Re: Guadalupe Power Partners, LP  
Guadalupe Generating Station  
Guadalupe County, Marion, Texas

## GUADALUPE POWER PARTNERS LP RESPONSE TO EPA INFORMATION REQUEST

### Guadalupe Power Partners LP – Guadalupe Generating Station Application for Greenhouse Gas Prevention of Significant Deterioration Permit

FIGURE 2-3.  
SIMPLIFIED PROCESS FLOW DIAGRAM OF A BASIC SIMPLE-CYCLE CT

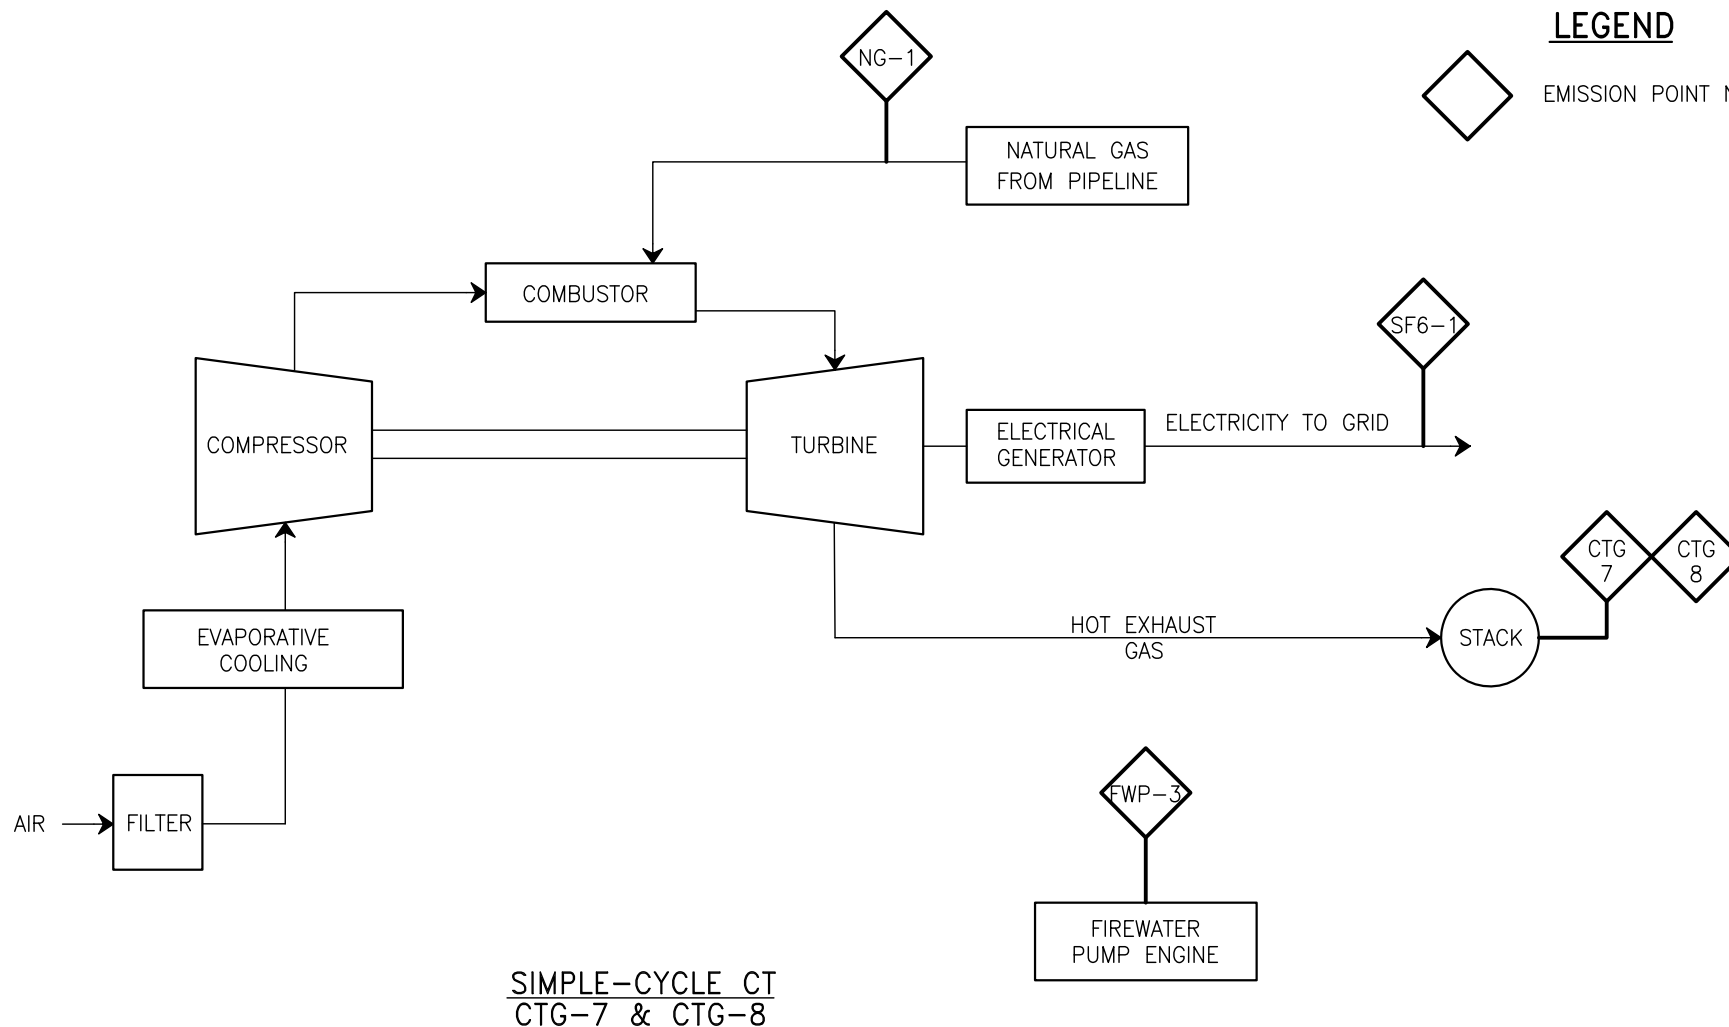
8. *Please provide emissions point numbers (EPNs) for the fugitive emissions and SF6 circuit breaker and confirm the EPN for the diesel-fuel fire water pump engine to be FWP-2. Please supplement the process flow diagram with a representation of these GHG sources and associated EPNs.*

The emissions point numbers for the sulfur hexafluoride (SF<sub>6</sub>) circuit breaker and the new firewater pump engine will be SF6-1 and FWP-3, respectively. In addition, the fugitive natural gas emissions point number will be NG-1. A modified process flow diagram showing the additional emissions point numbers is attached.
